RE: AURORA FOOD STORE
2000 ANAQUOD ROAD
REGINA, SK
Commission No. 2445

RE: Revise Rain Water Leader Distribution, Slope and Sizes

Project: Aurora Food Store
4801 Optimist Drive, Regina, Saskatchewan
Subject: Revise Rain Water Leader Distribution, Slope and Sizes
Date: 2025.06.05

Subject: Revise Rain Water Leader Distribution, Slopes and Sizes
References: Mechanical Drawing – M1.3 – Main Floor Plan - Plumbing

SHEET NUMBER:
M1.3P4

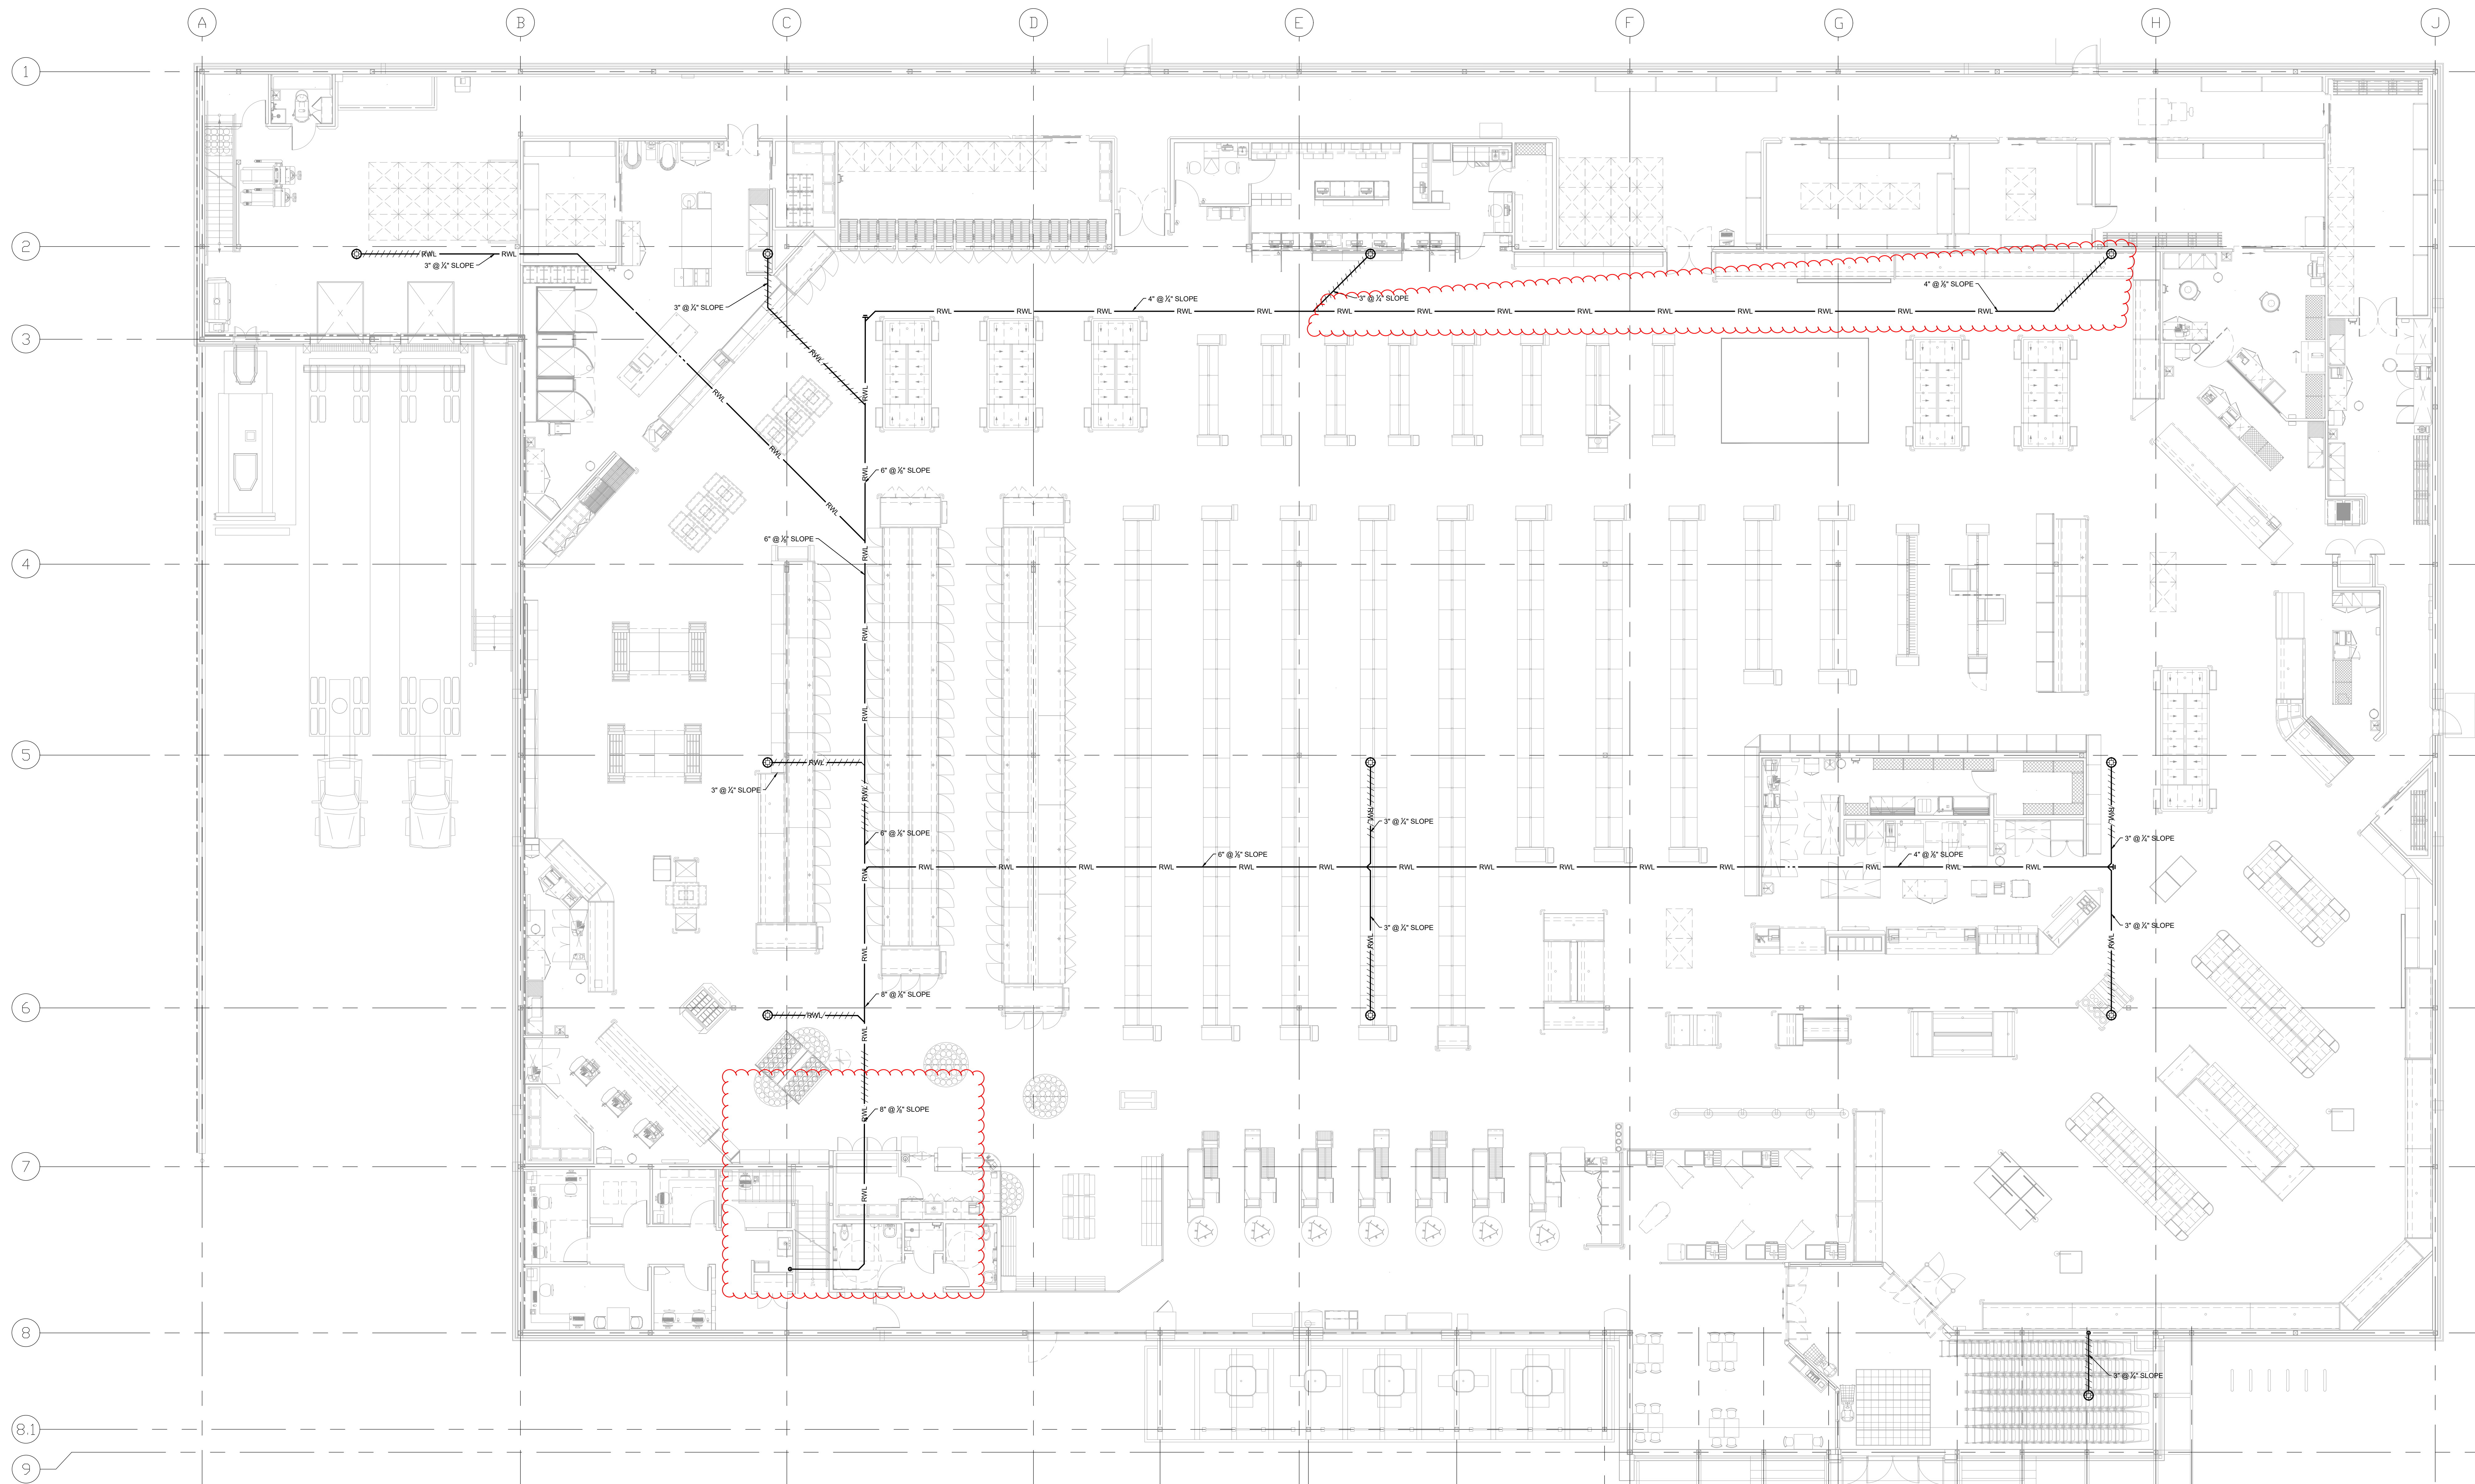
1. Revise rain water leader distribution, slope and sizes as shown on mechanical revision drawings M1.3P4. The Contractor is to coordinate the final layout with the structure and ductwork on site.

- .1 Delete 3" pipe and provide 4" RWL pipe near GL G.
- .2 Modify location of drain pipe running parallel to GL C.
